**Technical Assistance  
to  
Ohio Closure Sites**

**FINAL REPORT**

Recommendations to Address Contaminated  
Soils, Concrete, and Corrective Action  
Management Unit/Groundwater  
Contamination at Ashtabula, Ohio

*Technical Assistance #141*

**Figure 3.6. Simplified Schematic Diagrams of CAMU and Groundwater Options**  
(a) baseline conditions, b) cross section of Geodrain, c) AEMP site configuration options)

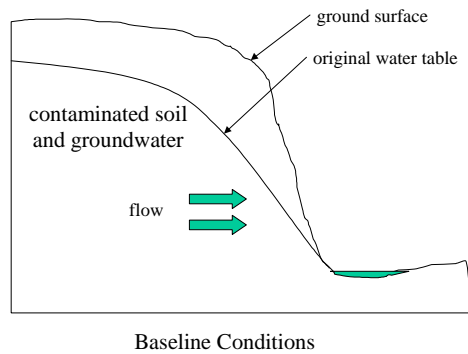
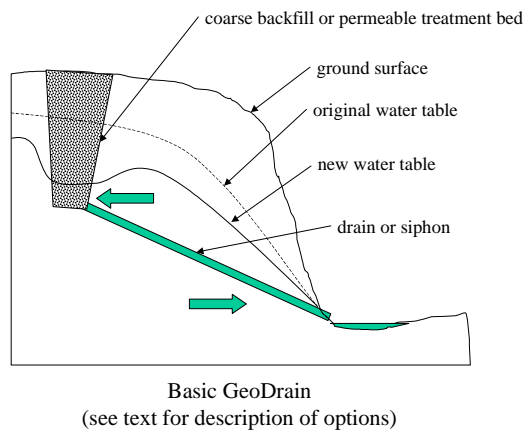
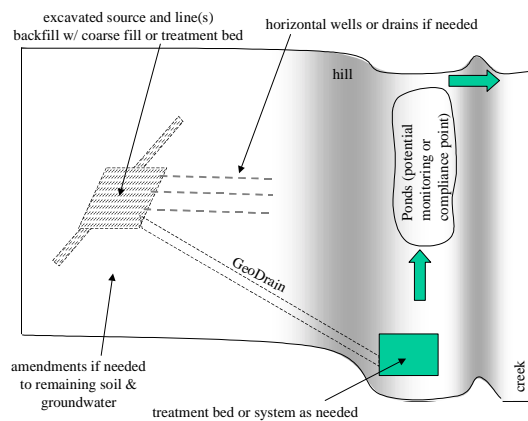
AEMP should also consider installing a high permeability backfill material to facilitate controlled drainage, possibly including amendments such as reducing agents and/or a

phosphate source. Transitioning to monitored natural attenuation for long-term strategy should be considered. The site could also consider drilling a down gradient drain or a geosiphon (as developed and studied at Savannah River) from the bottom of the excavation. This could be supplemented as needed by lateral horizontal wells or drains. See Figure 3.6 a, b, c above for details.
